SUBJECT: DEMONSTRATION / DELIVERY HOLD - Safety Recall 16S30 - *Supplement #3*
Certain 2013-2015 Model Year C-MAX and Escape, 2012-2015 Focus, 2015 MKC and Mustang, and 2014-2016 Transit Connect Vehicles
Side Door Latch Replacement

New! REASON FOR THIS SUPPLEMENT

DEMONSTRATION / DELIVERY HOLD - Safety Recall 16S30 - Supplement #3

FIGURE 1

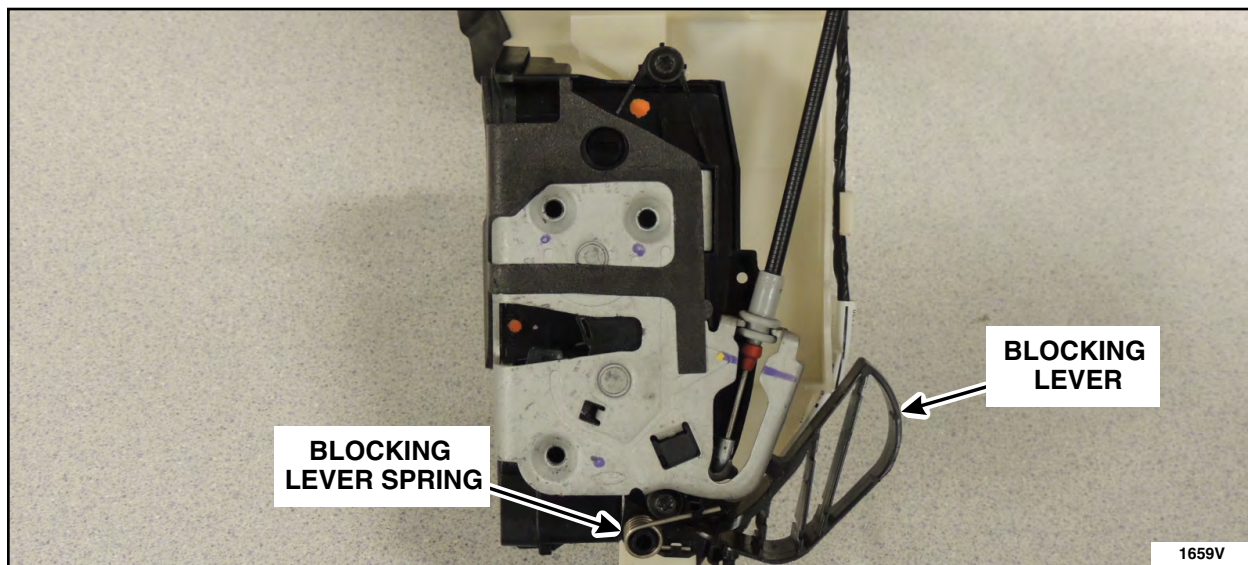
- The repair procedure is updated to remind dealers to transfer the blocking lever and spring, if equipped, along with all other components from the old door latch to the new door latch.*

IMPORTANT: If equipped, ensure that the blocking lever and blocking lever spring are transferred to the new door latch, along with all other components removed from the old door latch. See Figure 1.
